DESIGN REVIEW BOARD AGENDA
Lundeen Park Visitor Information Center (VIC)
10020 Lundeen Parkway, Lake Stevens
October 6, 2016

FILE NAME/NO: Tyler Subdivision (LU2016-0116 & 0117)
APPLICANT: C47-1 Tyler LLC
LOCATION OF PROPERTY: 10009 South Lake Stevens Road, Lake Stevens, WA 98258
ASSESSOR PARCEL NUMBER(S): 00457000003001
REQUEST: Design Review Approval of Subdivision
CONTACT PERSON: Melissa Place, Senior Planner

TYLER PROPERTY PRELIMINARY PLANS

SP-01
 SHEET 3 OF 8

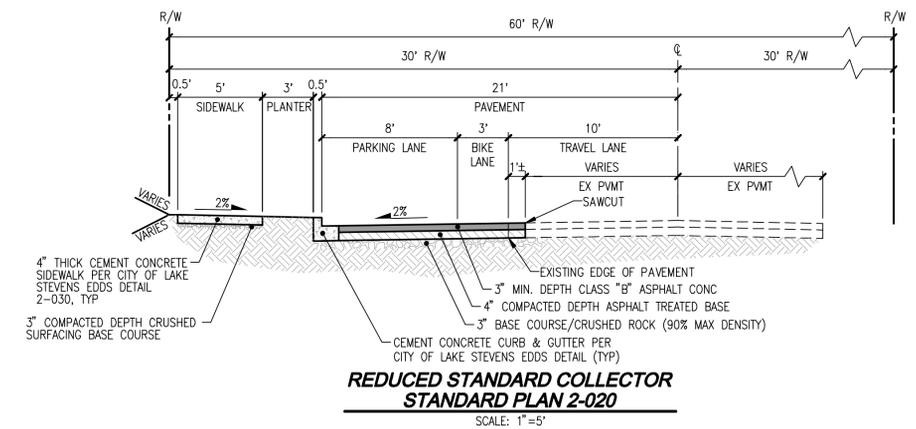
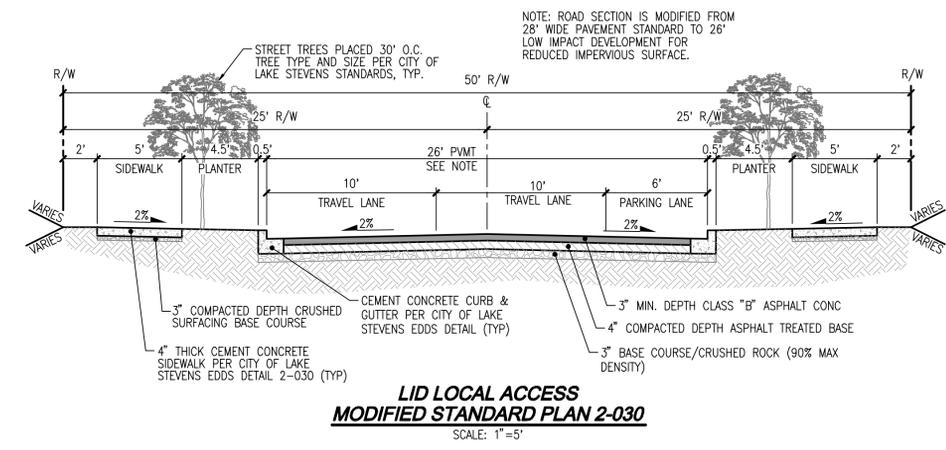
Findings: Open space will be provided in two Tracts (Tracts 998 and 999). In order to protect one Category III wetland, 16,134 square feet will be permanently protected from development in Tract 999. Tract 998 provides recreational open space and a playground over the proposed stormwater detention vault. The guidelines states that all neighborhoods shall have active open spaces with amenities. Staff would recommend a condition that the applicant provide details of the proposed recreational amenities/playground at the time of construction plan submittal to fully meet this guideline. The inclusion of recreational amenities/playground is optional and is not required by municipal code.

the property's frontage on S. Lake Stevens Road. The 20th St. SE Subarea Plan calls for a multi-use trail along S. Lake Stevens Road to ultimately connect with 24th St. SE. The applicant's plans do not currently show a multi-use trail, thus staff recommends a condition that the plans be revised to include the provision for a multi-use trail along S. Lake Stevens Road in conformance with the 20th St. Subarea Plan.

1. The project plans shall be consistent with the Plat Map (**Sheet SP-01 of Exhibit 3b**) presented to the Board except as modified by conditions stated herein, or as necessary to comply with conditions imposed on the land use permit by the Hearing Examiner or as hereafter amended with approval by the City.
2. Any subdivision signage will require a separate permit and administrative approval prior to installation.
3. Final inspection of the site Construction Plan shall not be commenced until staff has confirmed

6. The applicant shall revise the projects plans to include the provision for a multi-use trail along S. Lake Stevens Road in conformance with the 20th St. Subarea Plan.
